MFN 242-95
Docket No. 52-004

Subject: SBWR - Non-Proprietary Version of RAI Responses Submitted October
25, 1993

RAI Number: 440.1

Figure 3.2 SBWR High Reactivity Bundle Nuclear Design

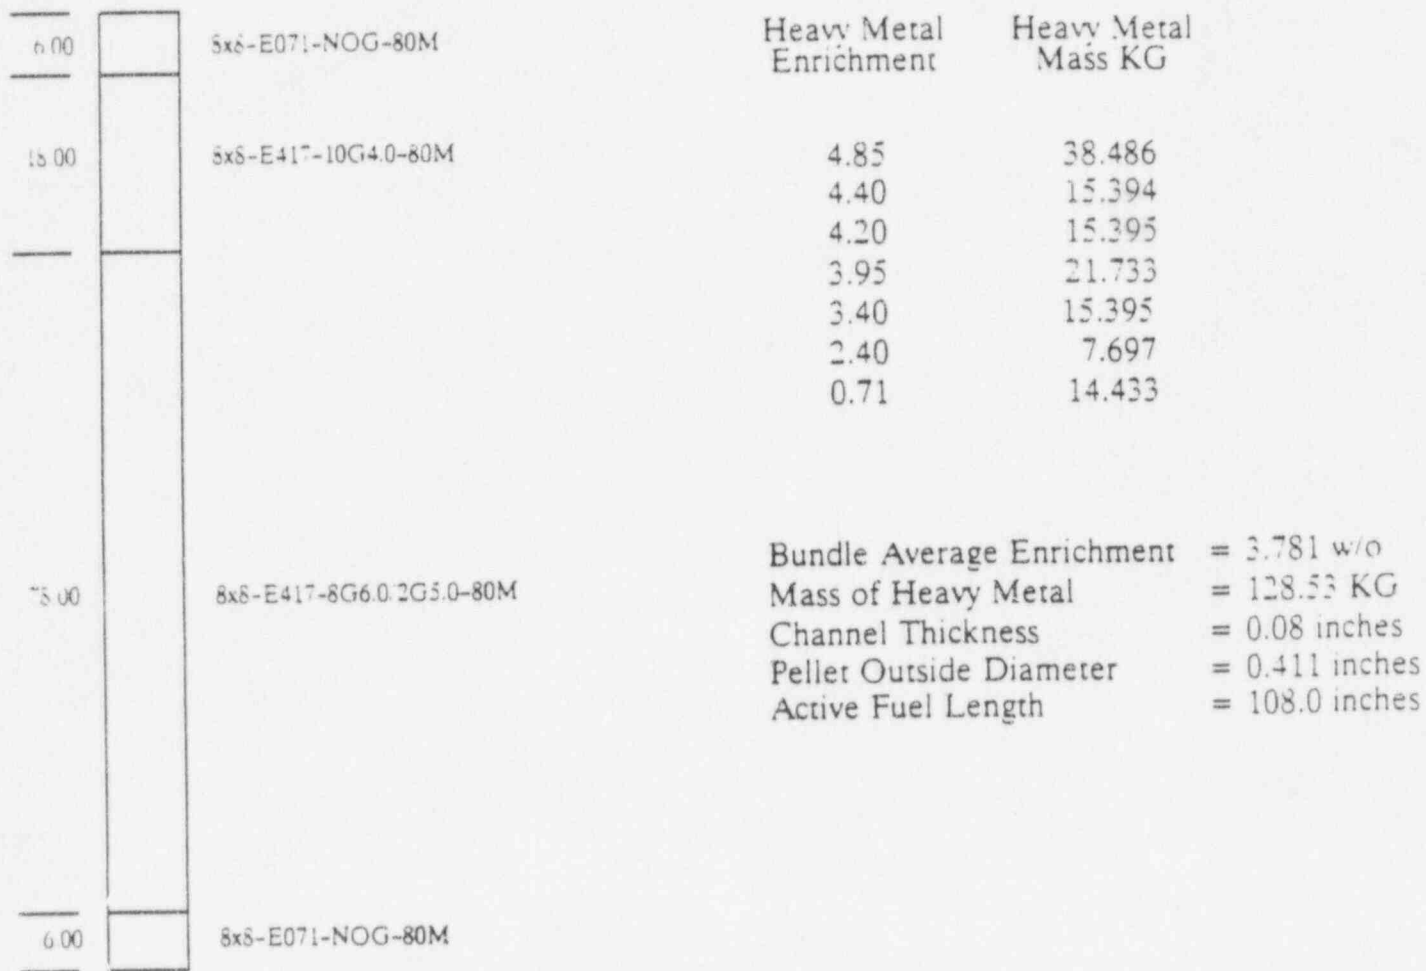
Describe where the four fuel lattice types in GE's May 21, 1993, letter are loaded axially into each bundle type in the core (i.e., axial fuel loading map).

Axial loading map attached (Figures 3.1 & 3.2 NON-proprietary)

Figure 4.7 SBWR 24 Month Equilibrium Cycle Loading Map

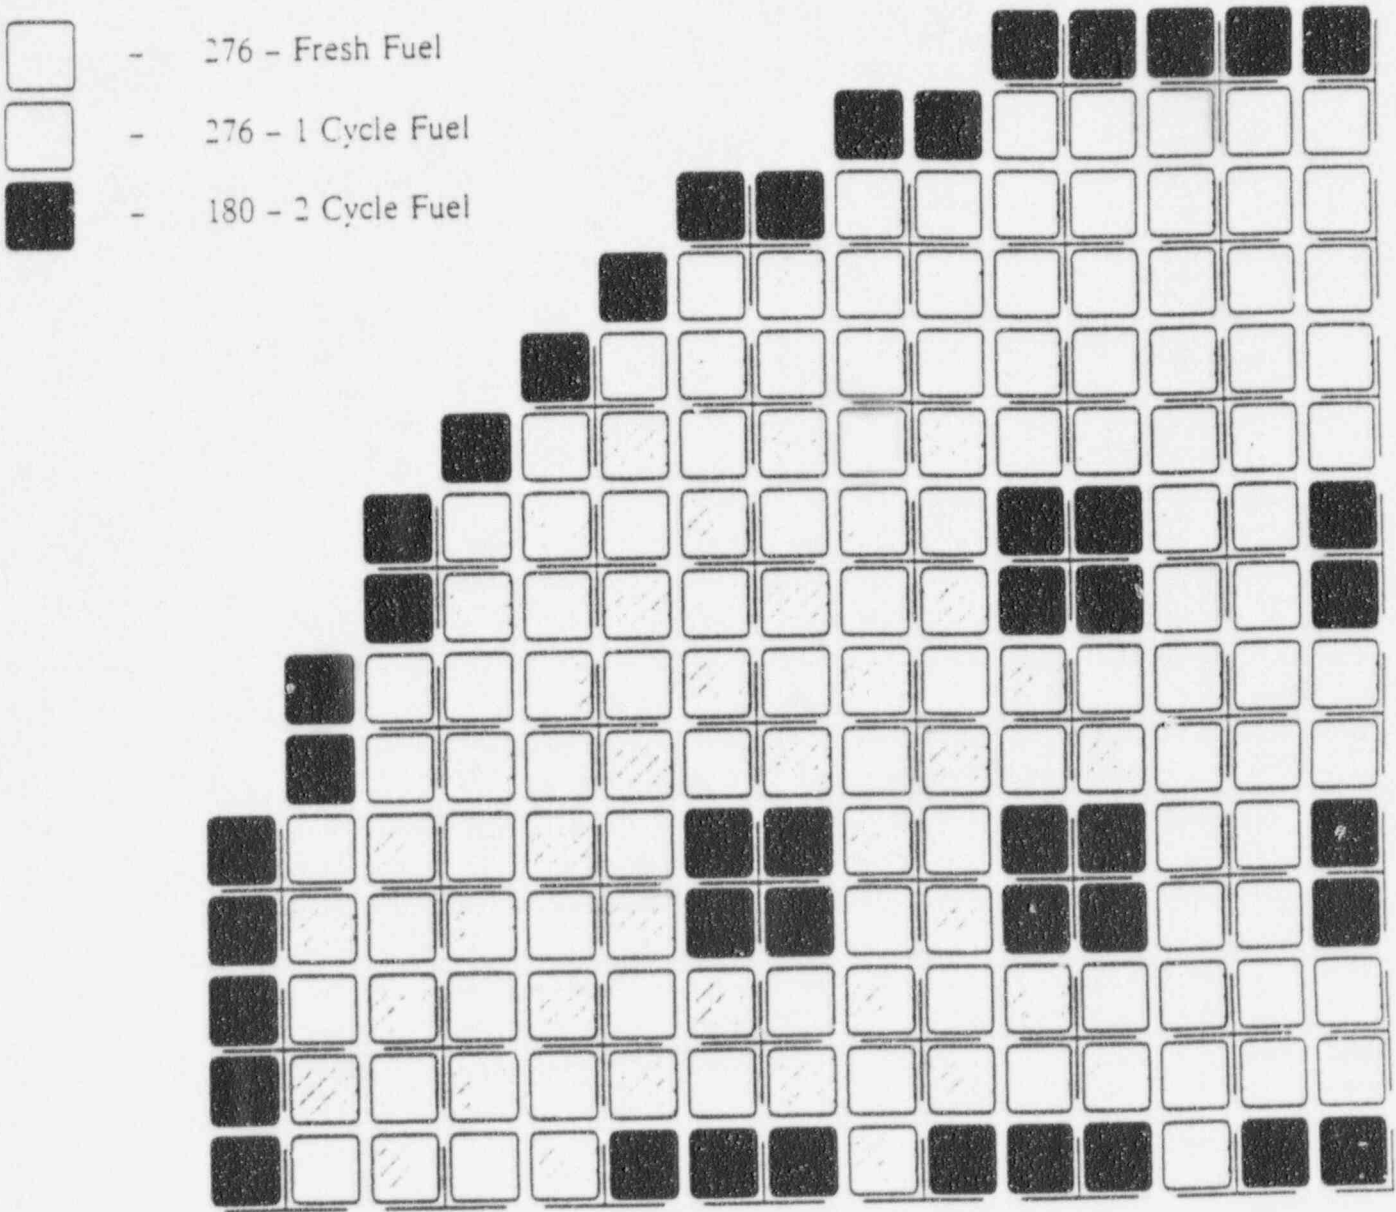
Provide the location of each bundle type in the core (i.e., radial fuel loading map).

Radial loading map attached (Figures 4.7 & 4.8 NON-proprietary)
